May 23, 2013

**Re: Ocotillo Wells Solar Major Use Permit (MUP) PDS2012-3300-12-004,  
Environmental Log No. PDS2012-3910-12-12-001; Proposed Mitigated  
Negative Declaration (MND)**

Figure 1. Small-scale image of the Project site. Yellow pins depict approximate corners of the property.

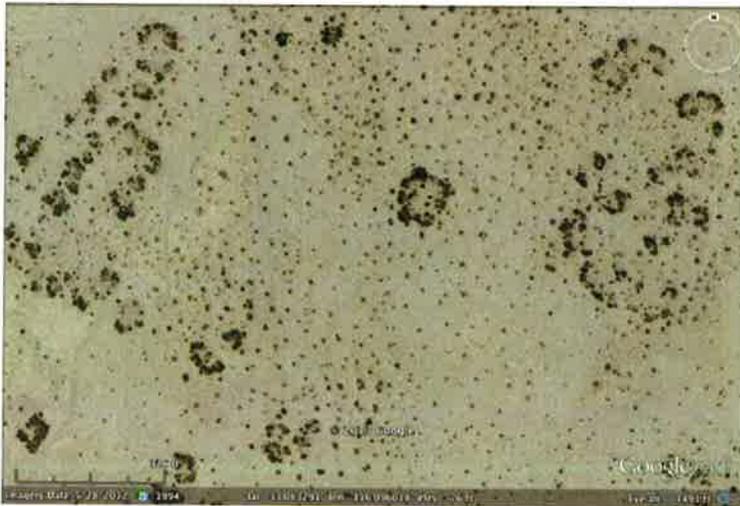
*spinosa* (Smoke tree woodland). In particular, Google Earth imagery suggests several mesquite bosques are located within areas that would be impacted by the Project (Figures 1 and 2).
